SIB 51 28 24

**RECALL 24V-764: REAR CARGO RAILS**

This Service Information Bulletin (Revision 1) replaces SI B51 28 24 **dated October 2024**.

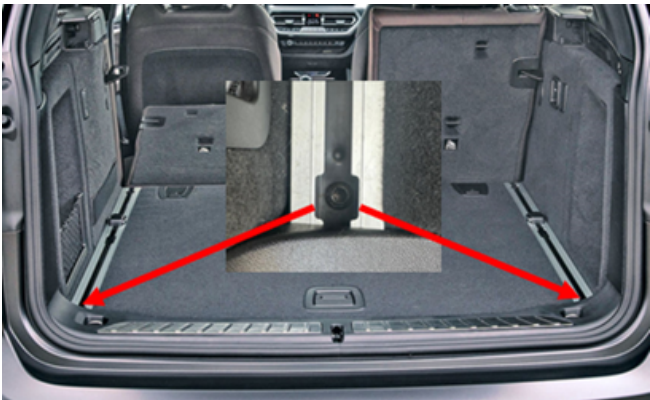
In an extreme rear crash, the attachment between the rear cargo rail (circled at left, new photo) and the vehicle body could become damaged. In a rare case, the rail could start to separate from the vehicle body, which could increase the risk of injury.

Remove and replace each of the rear screws (arrows) that secure the left and right cargo rails with a new screw. The washers can be reused.

1. Remove and dispose of the rear screws for the cargo rails (left and right).

2. Replace the screws with new screws and reuse the washers.

**Note: Tightening torque spec for the new screws is 19 Nm.**

- **At least 3 full turns of the screw must be achieved**
- **If one or both screws cannot be screwed in or if the three turns of the screw cannot be achieved, the thread must be reworked with a heli-coil thread insert**
- **The reworking with a heli-coil thread insert can be carried out on the installed cargo rail**
